PLAN COMMISSION STAFF REPORT

JANUARY 21, 2016

THE RESERVE

SITE PLAN REVIEW

LANDSCAPING

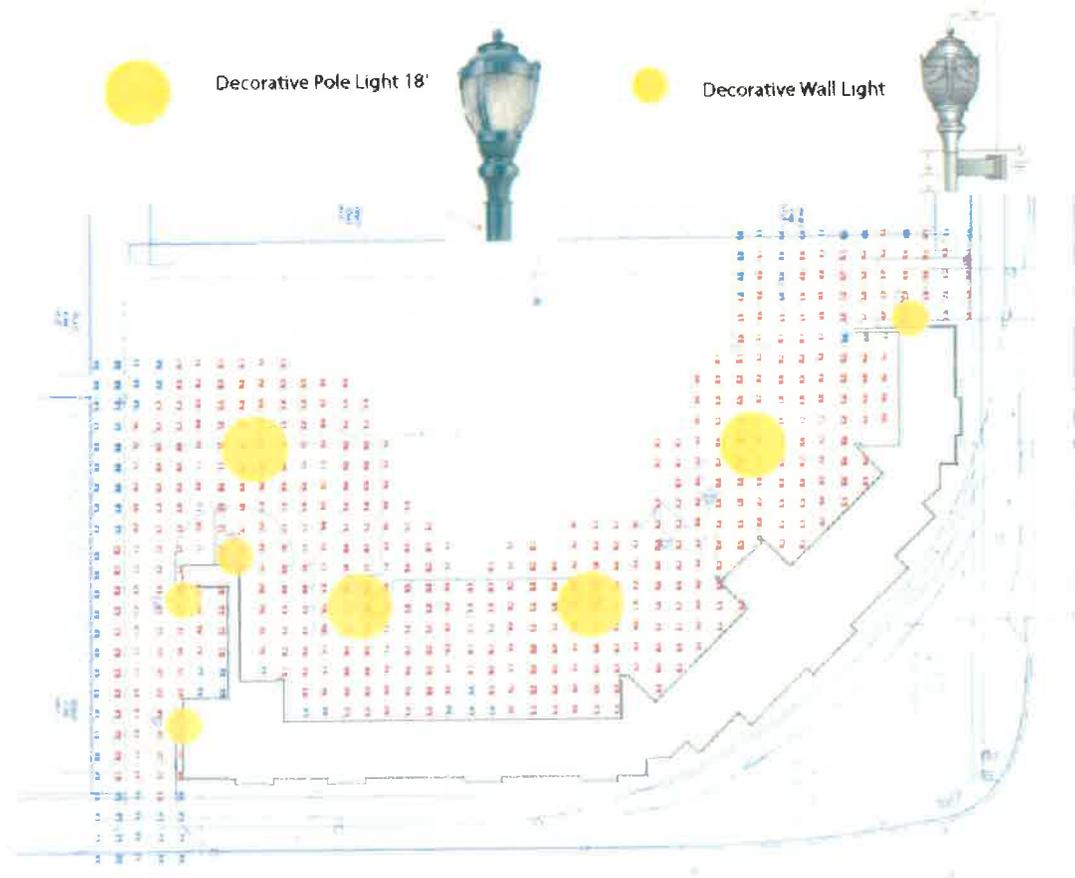
In addition to the bufferyard, the parking lot must meet the 15% interior landscaping requirement for parking lots. The proposed plan provides 15.2% of the parking area as landscaping. Street trees are also required at a rate of 1 tree per 25' linear feet of frontage. Due to the overhead lines along both street frontages, staff recommends the use of ornamental trees rather than shade trees. Twenty-three ornamental trees are provided along the street frontages. The applicant also provided landscaping in the large triangular area in the parkway adjacent to the intersection per staff recommendation. Shade trees have been provided adjacent to the tot lot and the parking areas at the rear of the property. Appropriate seed mix has been provided in the storm water detention area consistent with IDOT seeding recommendations. Per the Legacy Code interior lot landscaping for multi-family units are required to provide 1 tree per dwelling unit. While the proposed plan provides some additional trees, the plan still does not meet code. Staff is working with the Applicant to bring the plan into compliance.

Open Item #2: Landscape Plan does not meet Village requirements.
